TECHNICAL SERVICE BULLETIN

Victory Motorcycle

Bulletin Number: V-16-01A-C
Model Years: 2015-2016

SUBJECT: Victory International Cruiser—Exhaust Emissions

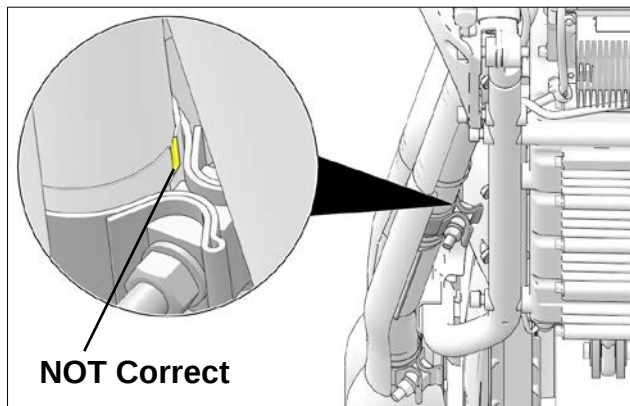
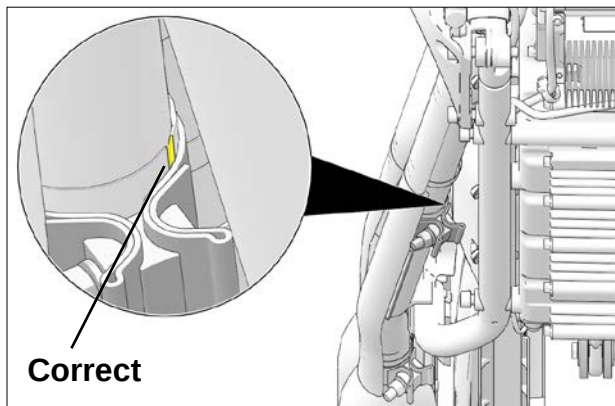
1. Locate the exhaust clamp between the mid pipe and the header pipe, shown below.
2. Inspect the placement of the clamp.

Clamp should be located at the front edge of the slotted mid pipe or up to 6mm (1/4 inch) depth ① toward the rear of the motorcycle. The clamp should never be located forward of the front edge of the slotted mid pipe.

3. Inspect the rotation of the clamp.

Open section of clamp should not line up with slot in mid pipe and be at least 45° away from the slot on either side. Band of the clamp should cover slotted sections of the mid pipe.

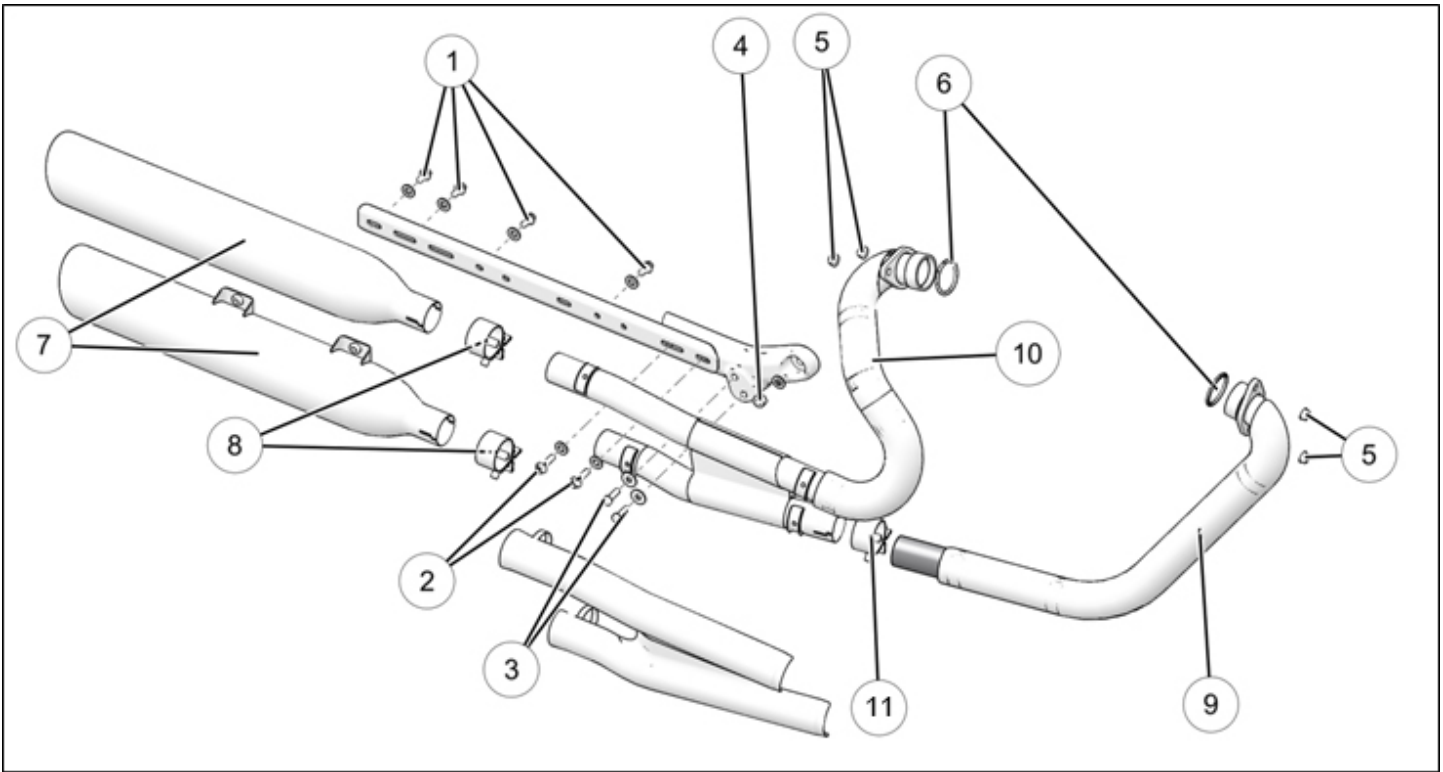
If clamp placement and rotation are **CORRECT**

File a warranty claim for V-16-01B. No further action is required.
